AGENDA OF THE PLANNING
COMMISSION
CITY OF BIRCHWOOD VILLAGE
WASHINGTON COUNTY, MINNESOTA
August 27, 2020
7:00 P.M.

CASE NO. 20-02-VB 415 WILDWOOD AVE

CASE NO. 20-04-VB 251 WILDWOOD AVE

**VARIANCE CASE
NO. 20-02-VB**

WANDMACHER RESIDENCE		
415 WILDWOOD AVE BIRCHWOOD, MN 55110		
client:		
scale	date	revision
1" = 8'	6/8/20	
drawn by	checked by	drawing #
ROSALIE TALLEN	651 426-1500

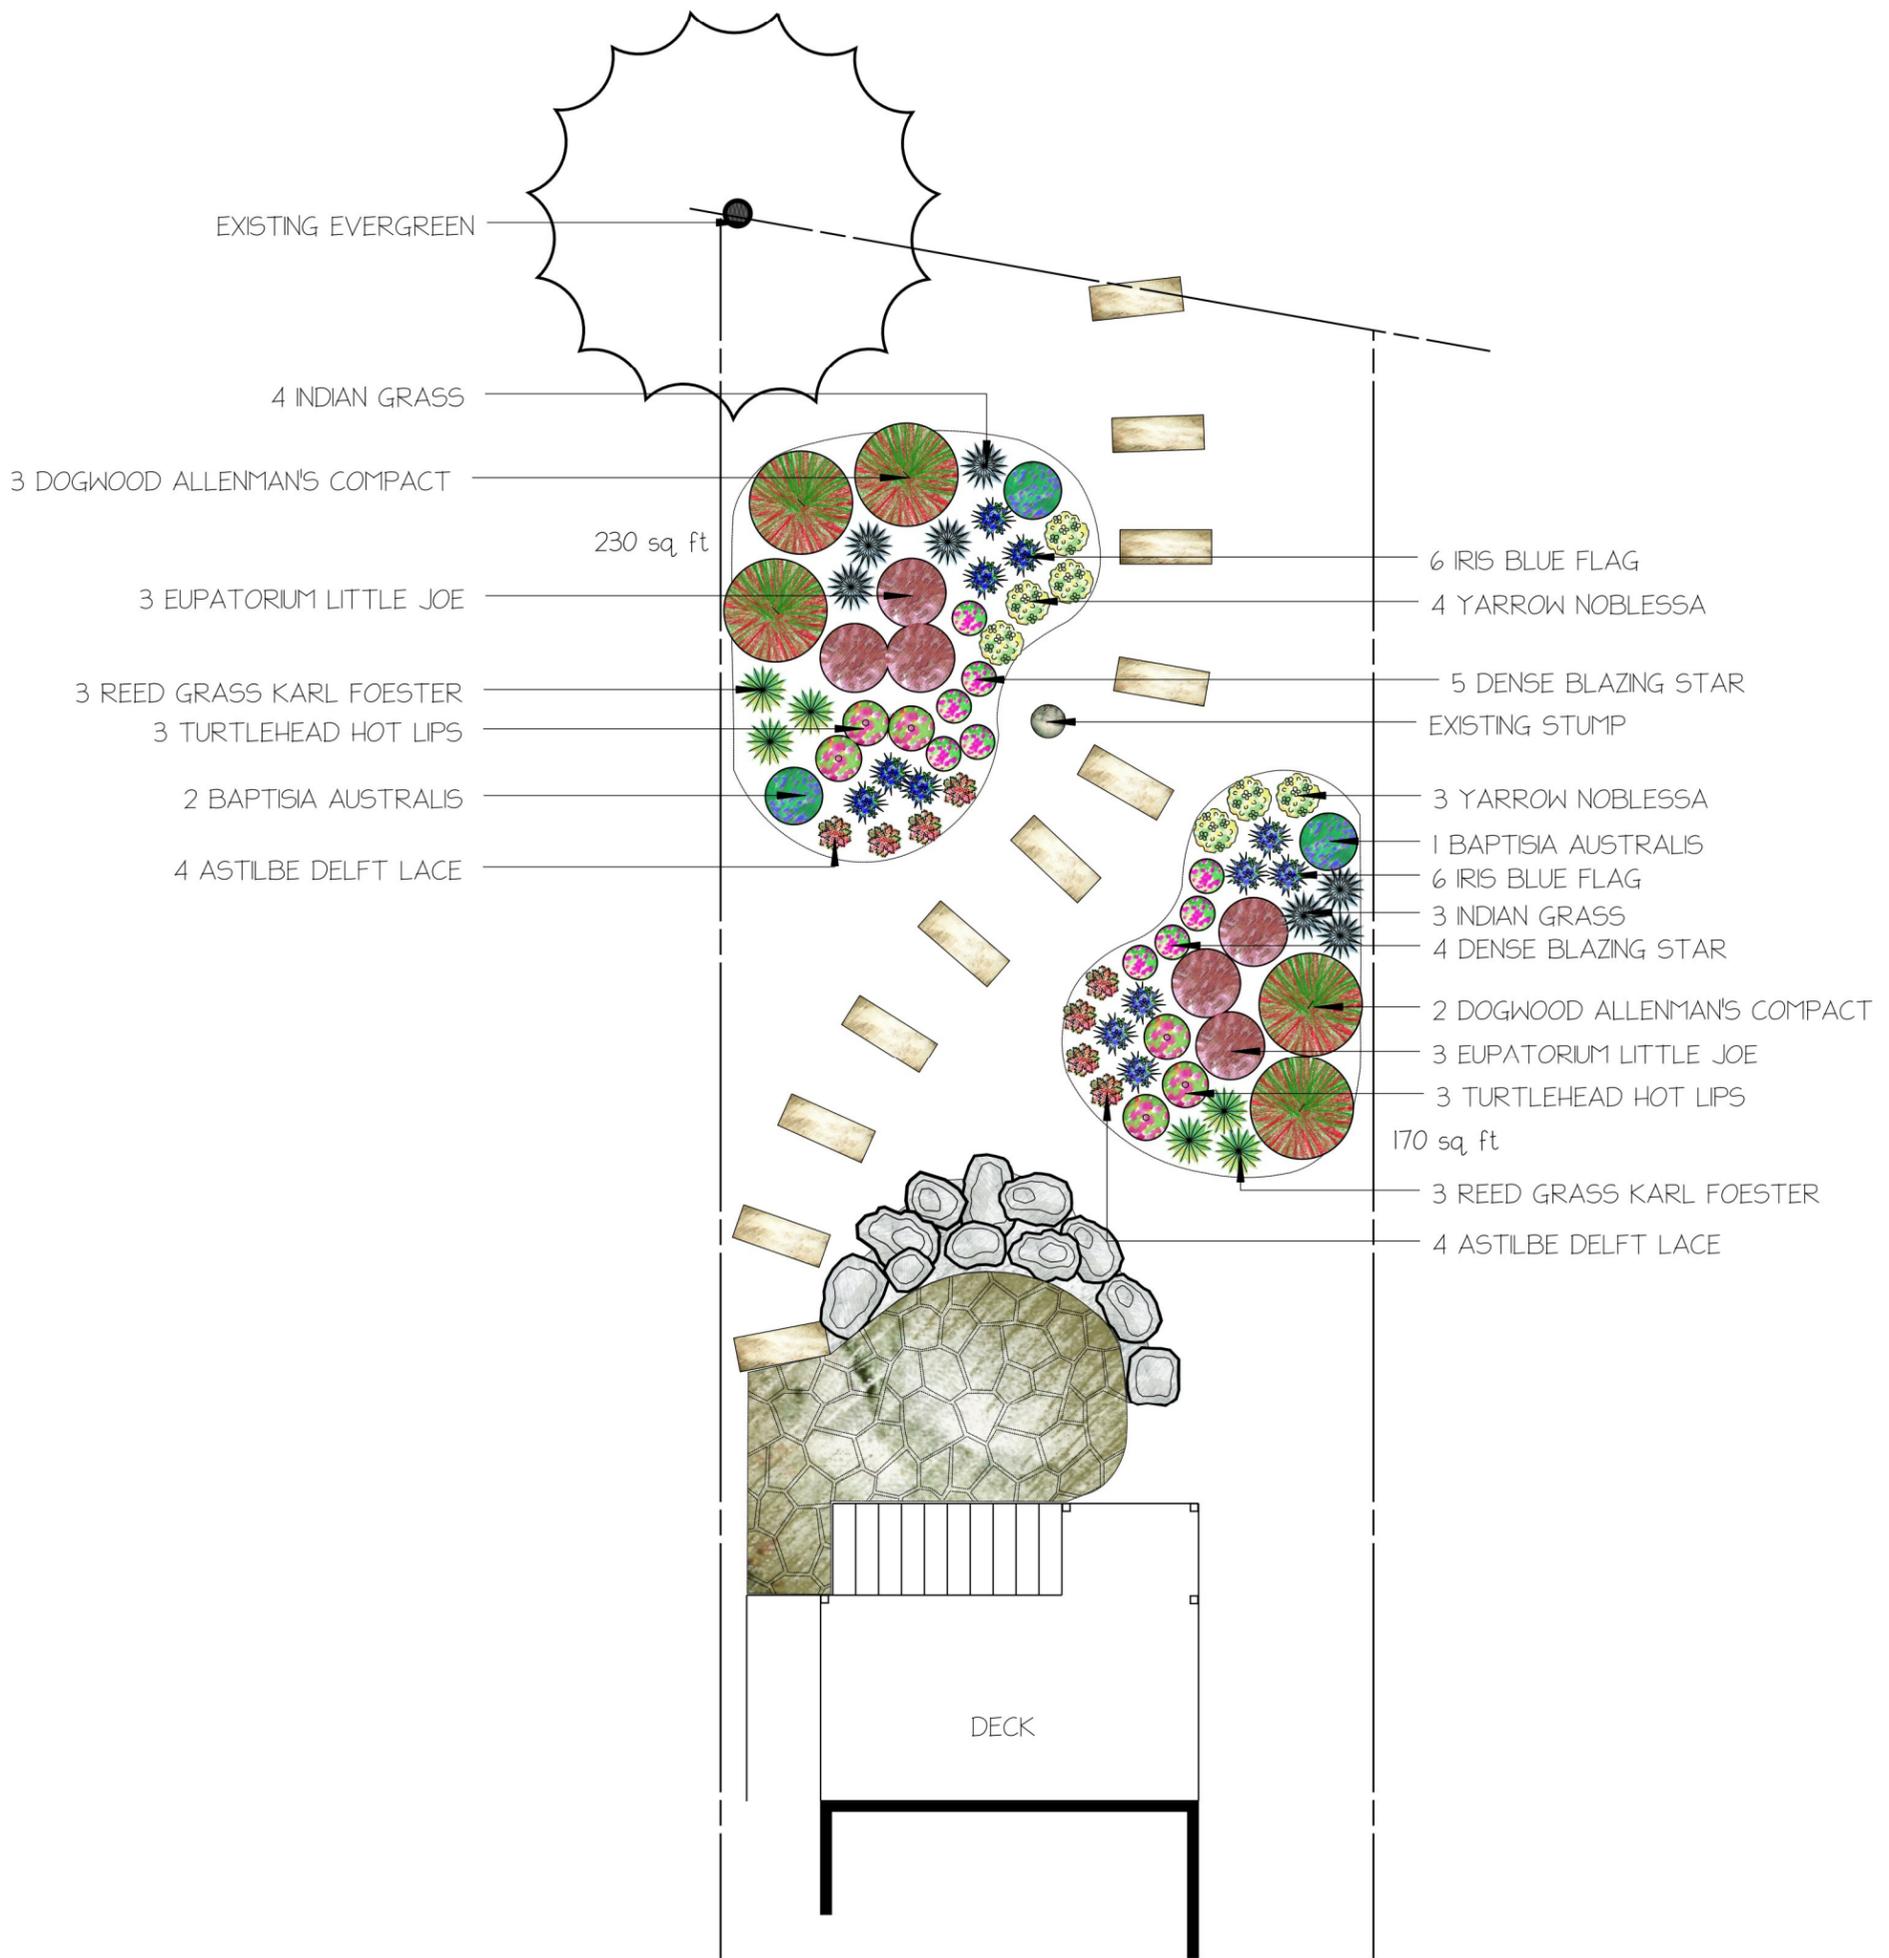
FORMULA: Your total lot area is 6,768 sq ft (from the property records). Divide your impervious area by your total lot area. That will be your 'percent impervious' they are looking for. You will have to show the change from EXISTING to PROPOSED impervious (demonstrating what your new patio will add to the total)..... So add up all your EXISTING impervious areas (rooftops, driveways, sidewalks, patios, and gravel surfaces). Do not include your new patio in your EXISTING calculation. Once you have that number, the formula looks like this: Percent EXISTING Impervious Area = (EXISTING IMPERVIOUS AREA) / (TOTAL LOT AREA)

EXISTING IMPERVIOUS: House = 912sq ft, Garage = 400sq ft, Sidewalks and Driveway = 800sq ft ADD THEM UP = 2112

Add in your proposed patio to the above numbers and divide that by 6768.

$2112+400 = 2512$

$2512/6768 = 37.1\%$ PROPOSED Impervious
